## INVITATION FOR BIDS

CCK-2844.00-1-25

Princeton Greenhouse - Headhouse

ADDENDUM #1

A-201

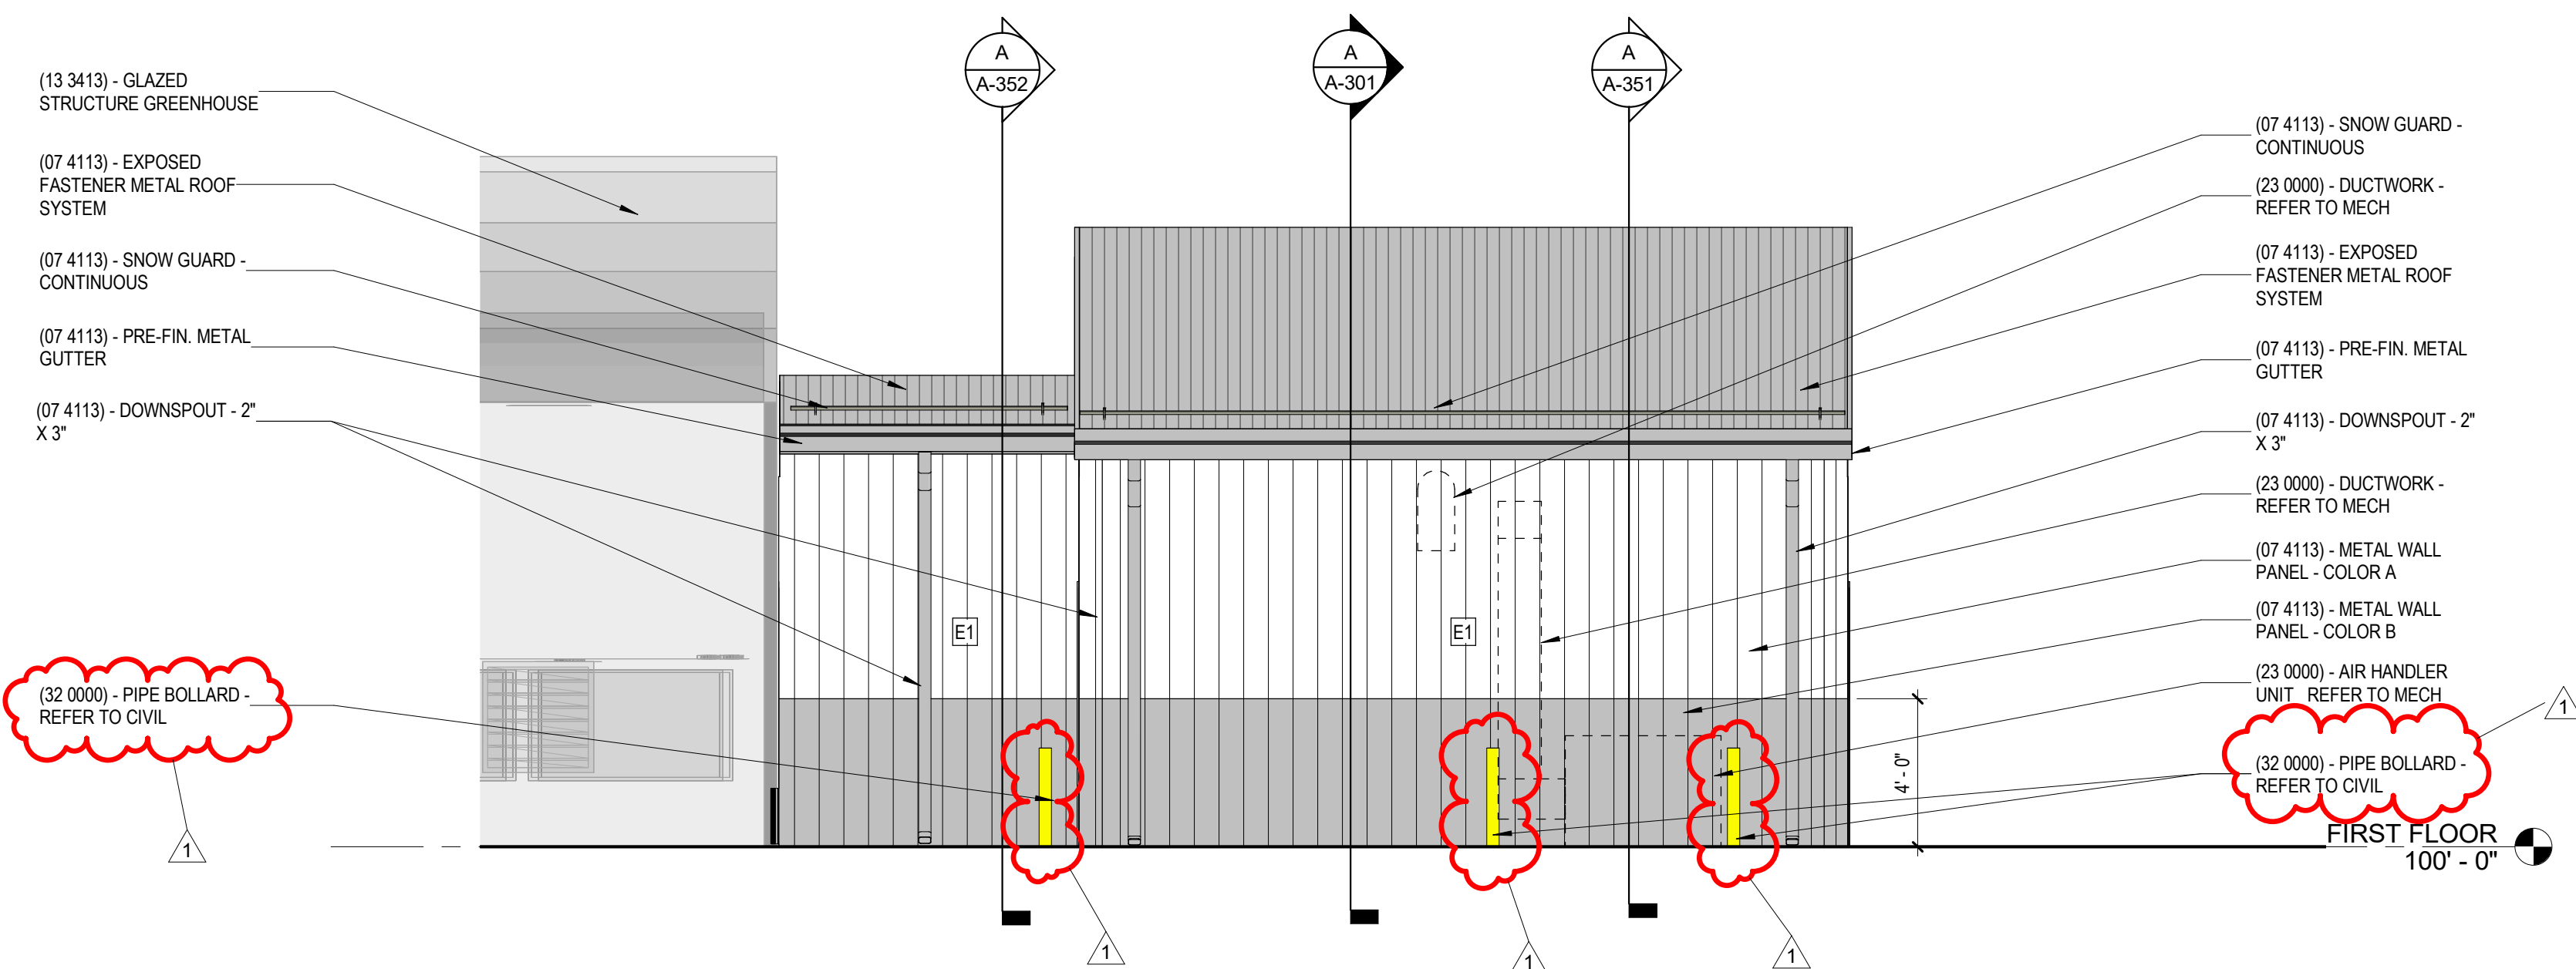
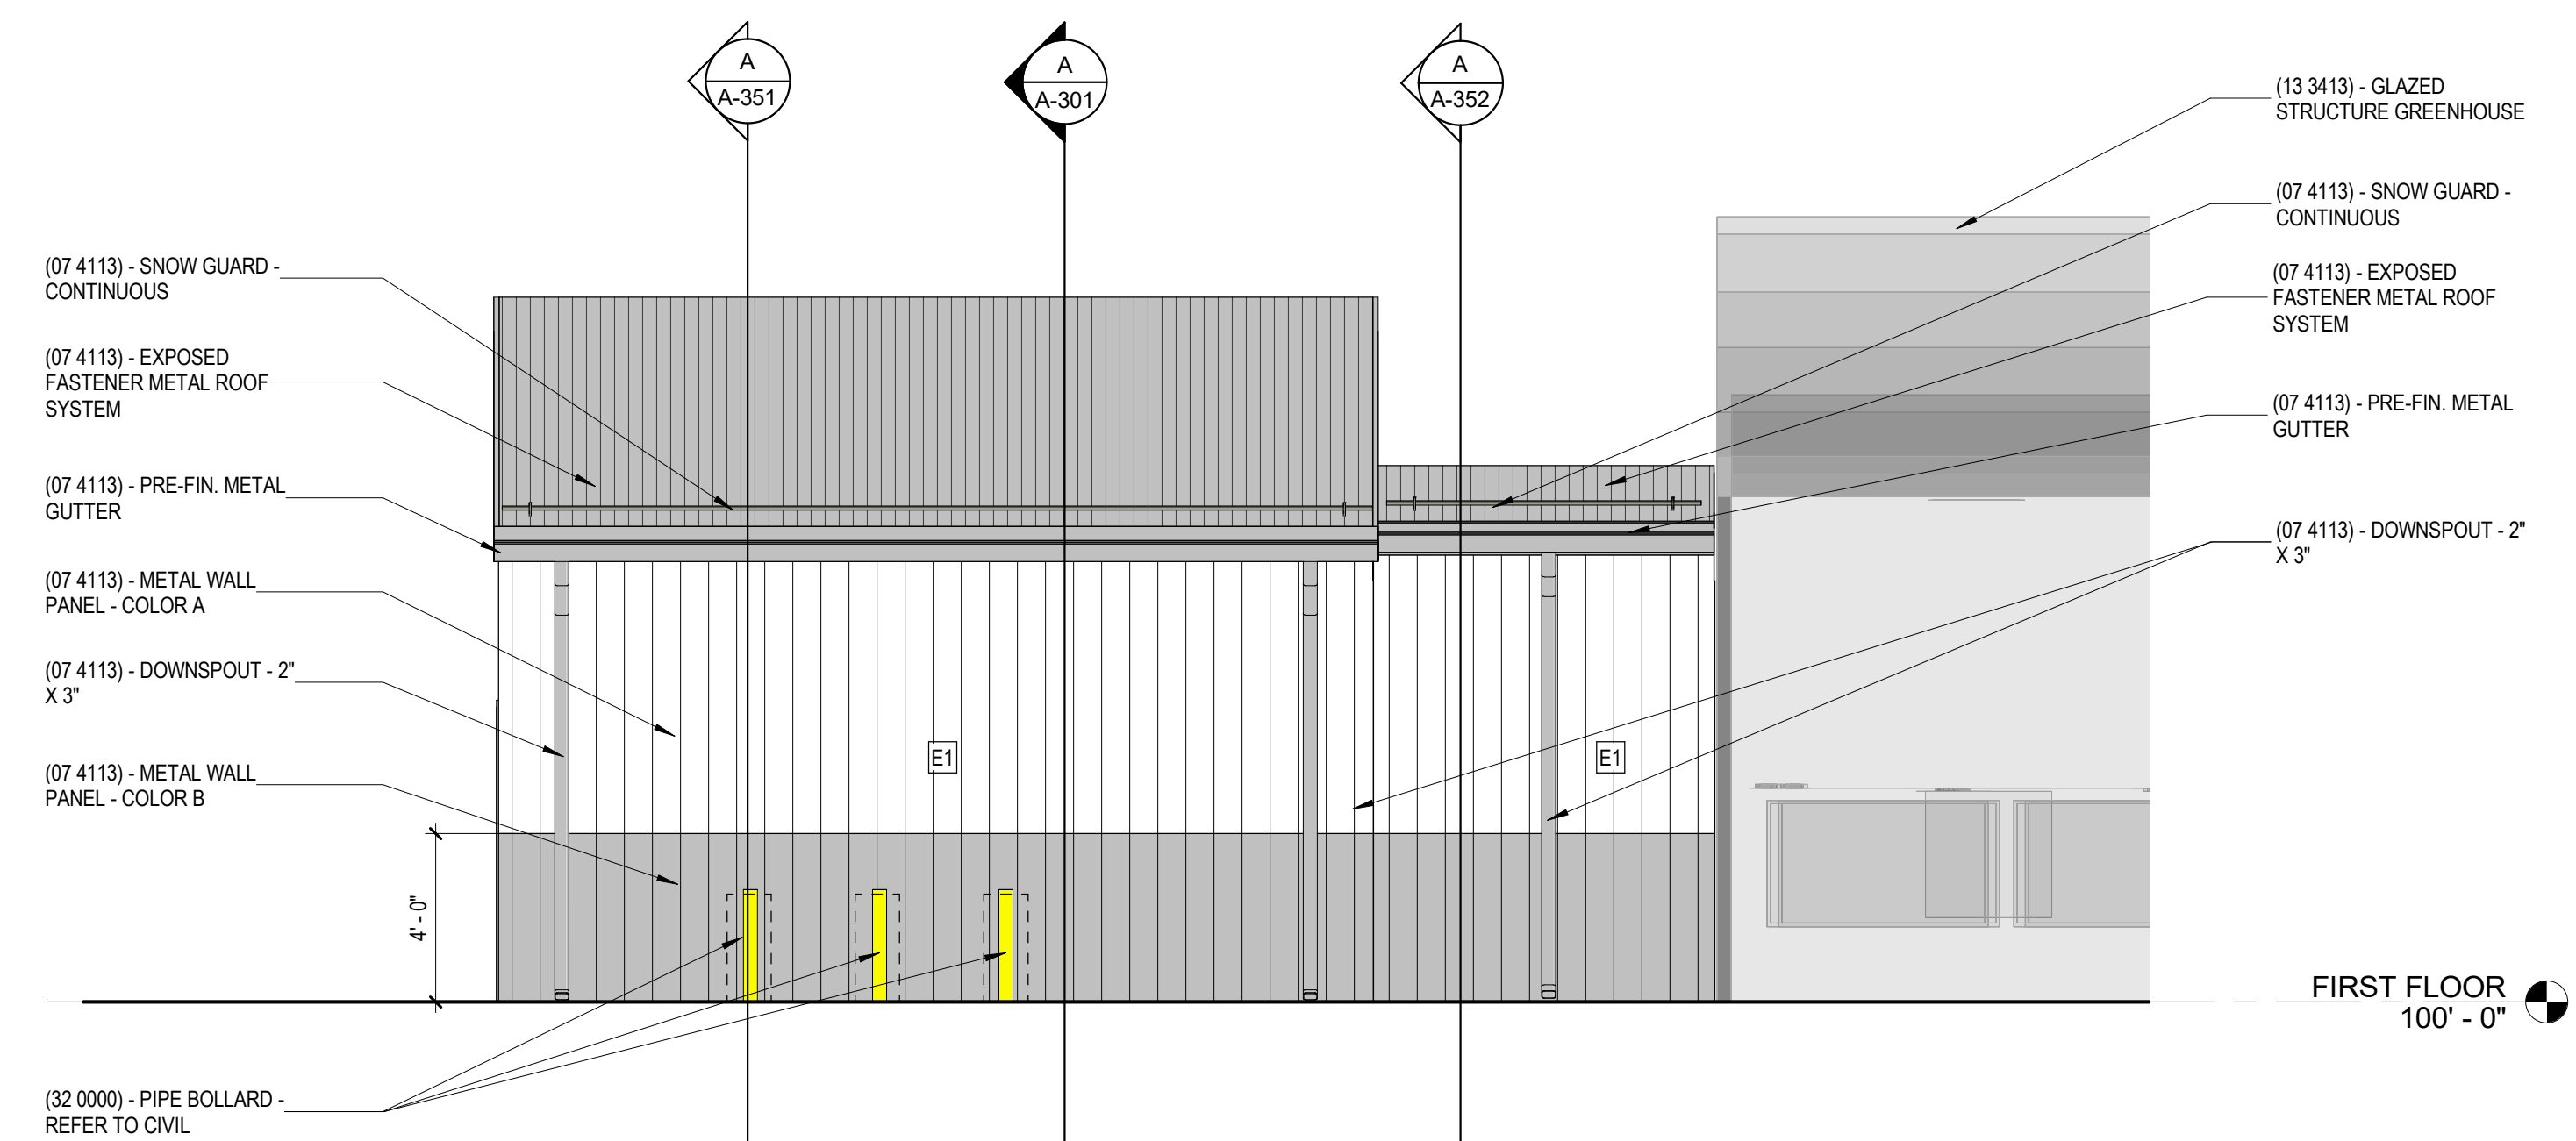
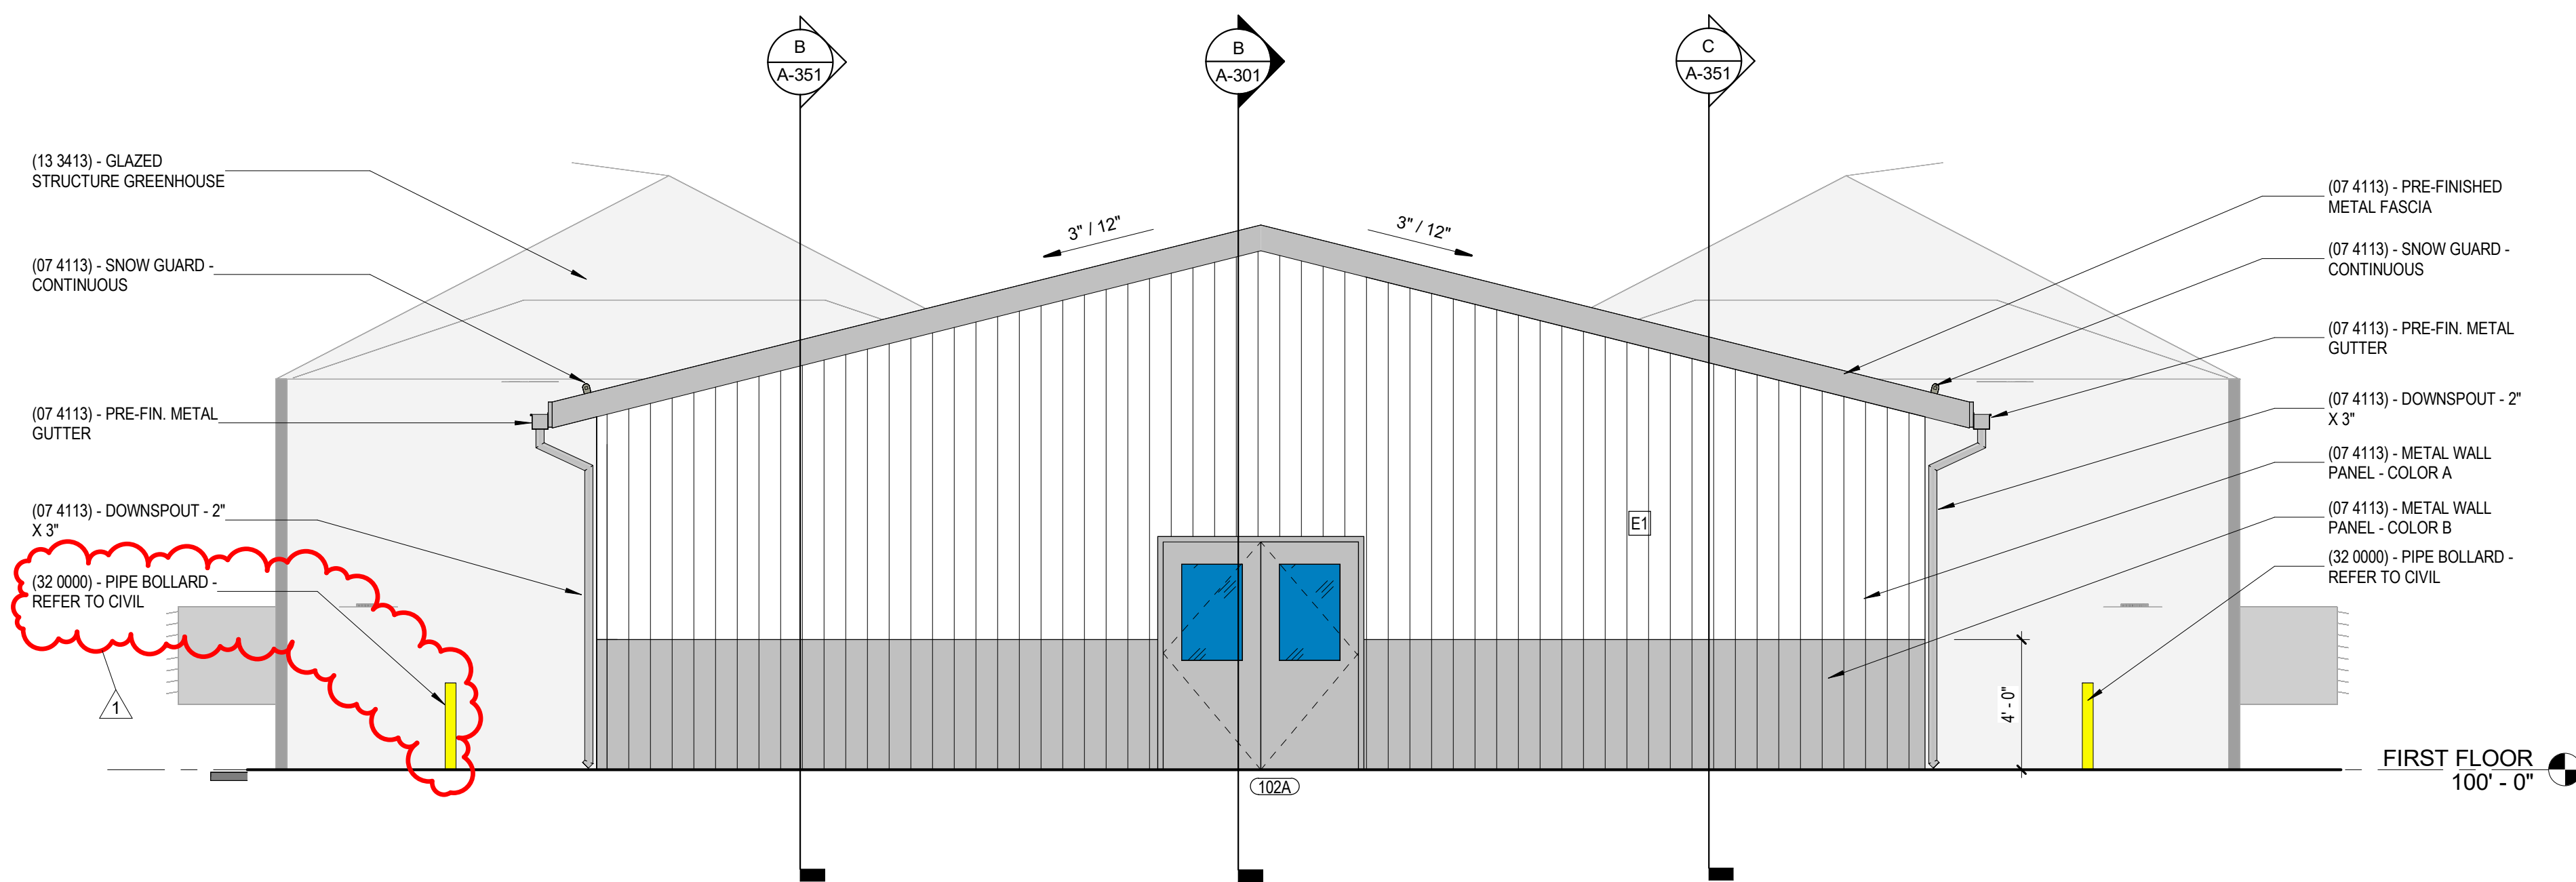
Refer to attached sheet A-101, A-102, A-201, A-202. Added bollards around HVAC unit, generator, and gas meter. Refer to civil & electrical for additional information.
